REMARKS

The application is directed to a method and apparatus using a multi-carrier forward link in a wireless communication system. The 1X FDD mode operates within a 1.25 MHz bandwidth on both the forward and reverse links, thereby providing for higher capacity in the 1.25 MHz bandwidth and supporting high-speed data transmissions. The spreading rate is 1.2288 Mcps on both the forward and reverse links of 1X systems. The 3X mode operates within a 5MHz band on both forward and reverse links. The 3X mode forward link employs a multi-carrier transmission format where three signals are spread at a spreading rate of 1.2288Mcps. By using the 3xFDD mode and providing a forward link using the multi-carrier format, a communication system is fully compatible with existing IS-95 systems. That is, the cdma2000 forward link structure may be "over-laid" on existing PCS systems. One attribute that makes the forward link multi-carrier system compatible with existing systems is that it preserves orthogonality of signals transmitted in the forward link. The reverse link is not orthogonal, so cdma2000 systems use a direct spreading to 3.6864 Mcps.

FIG. 5E

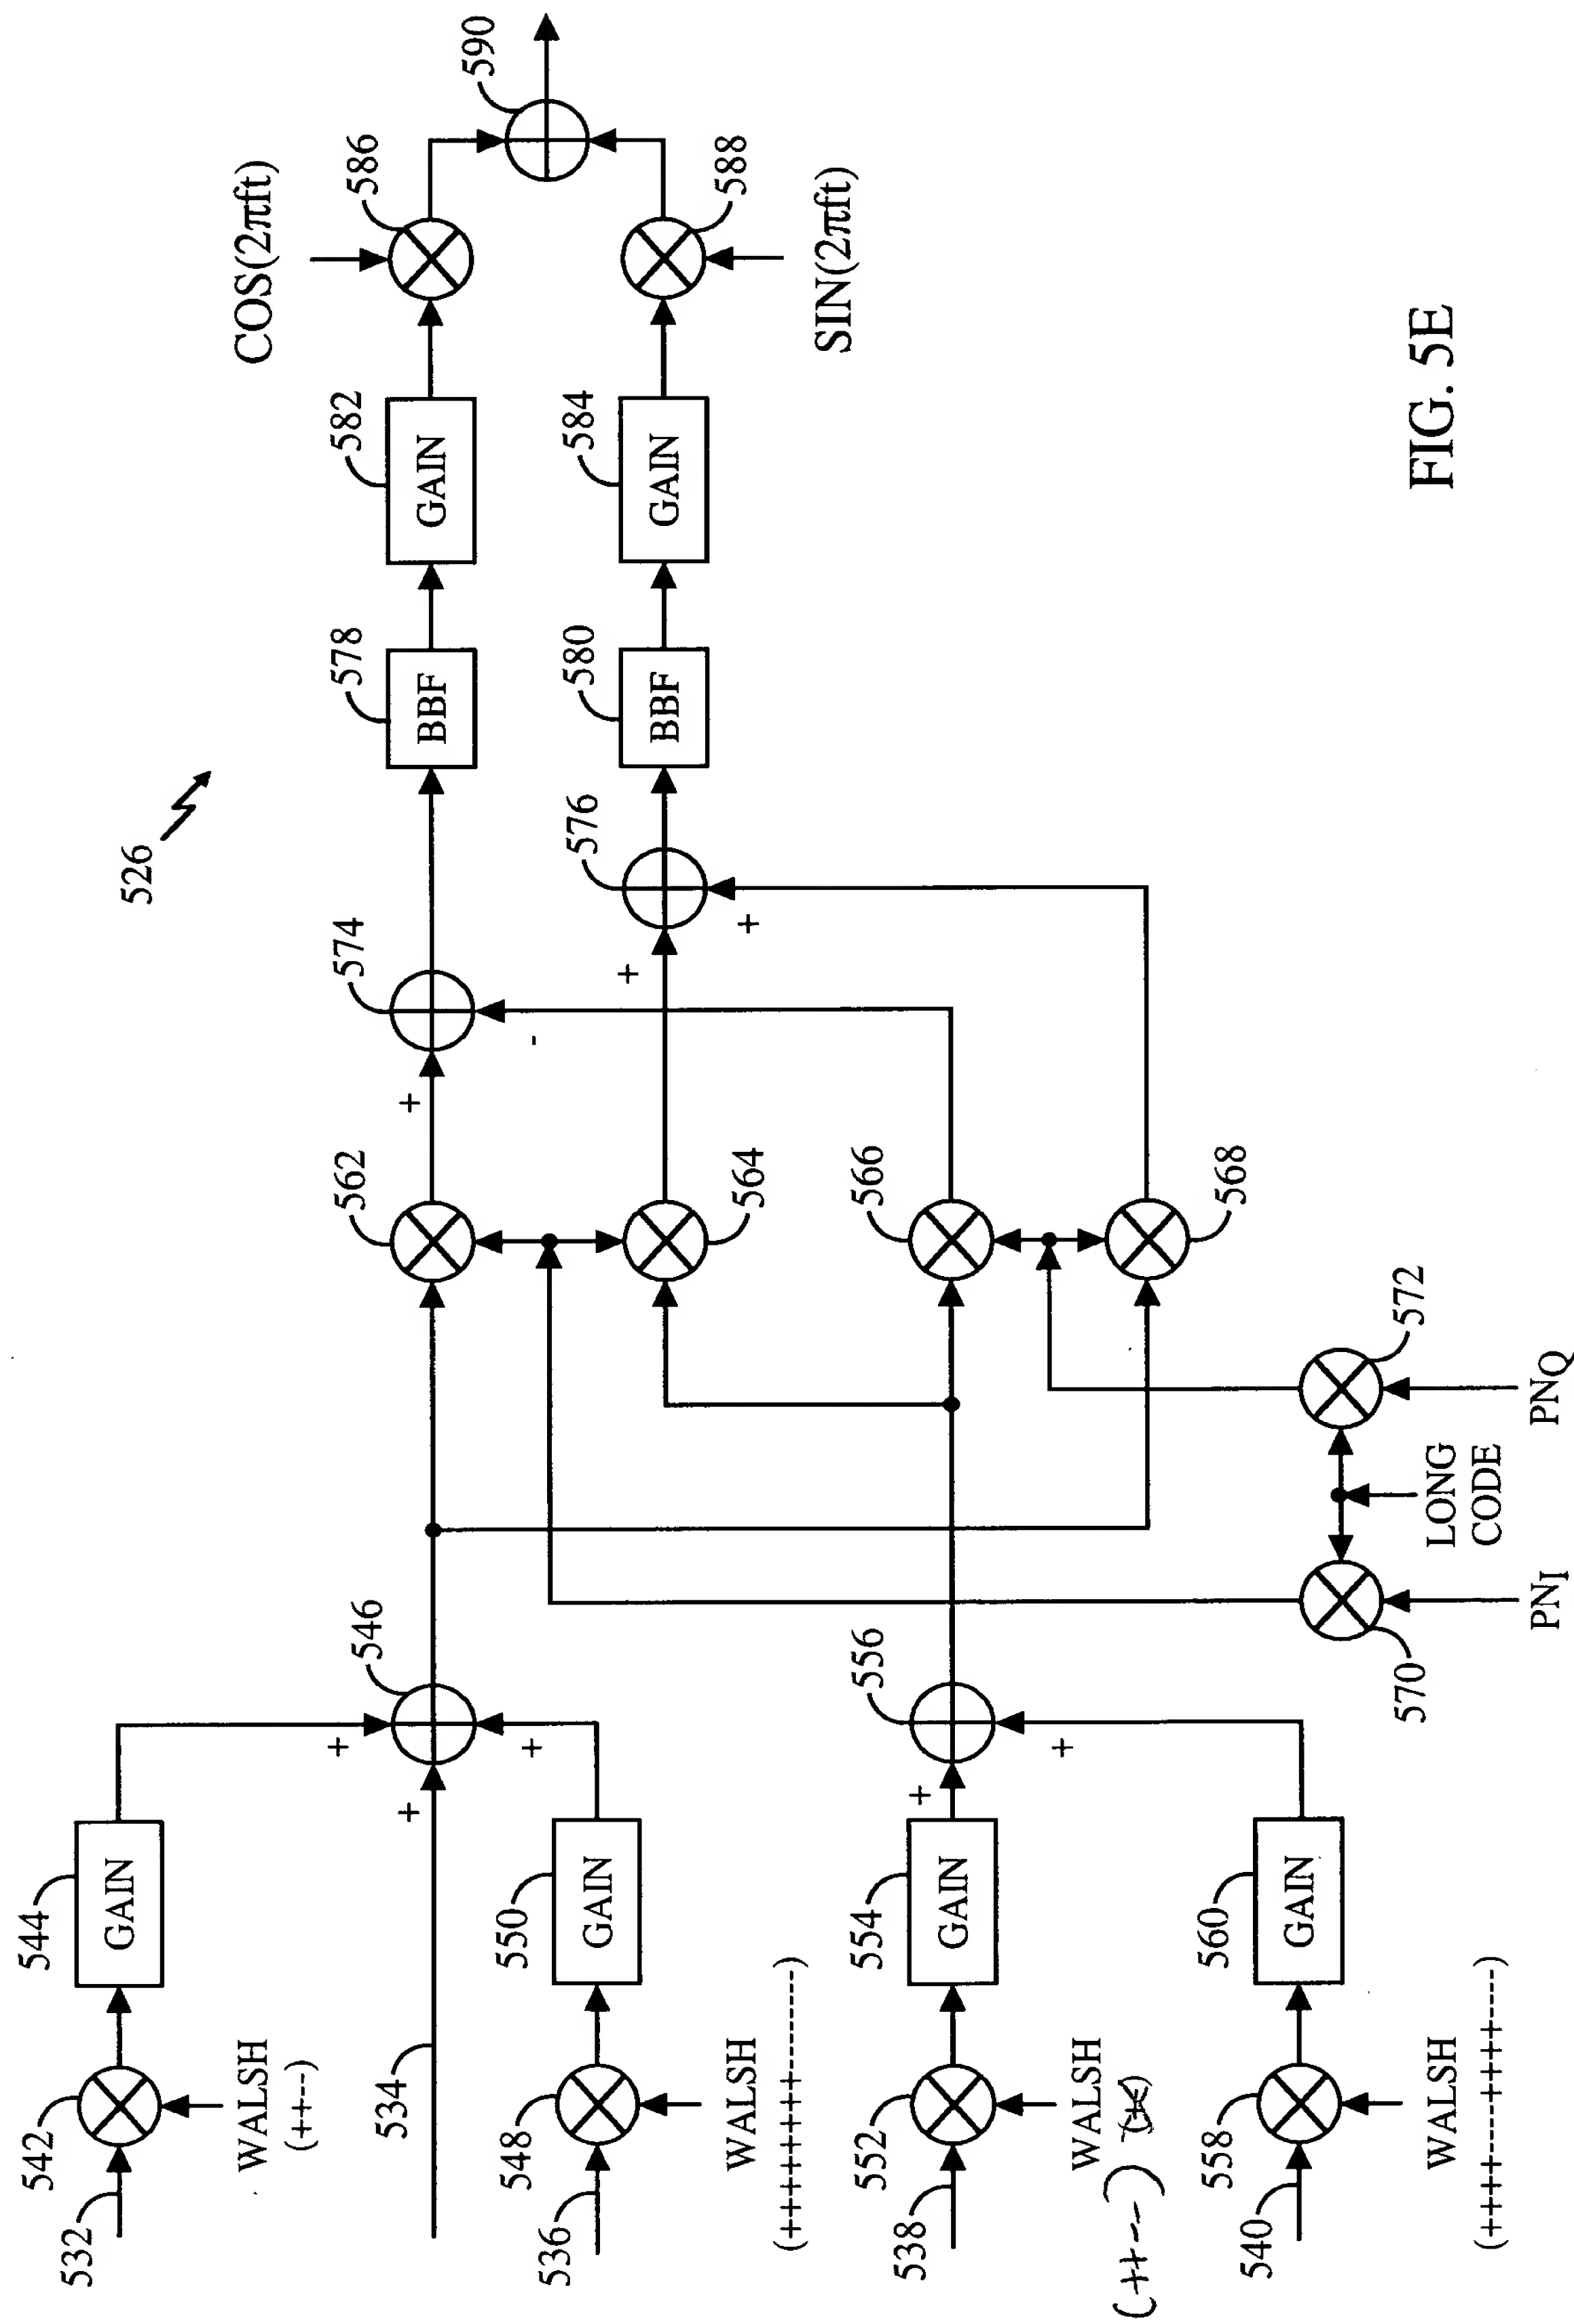
The drawings are objected to because Fig. 5e part number 552 should have "Walsh (++--)" not "Walsh (+-)" so as to match page 25 line 23 and page 24 line 1. Applicants amend Fig. 5e to incorporate Examiner's recommended corrections.
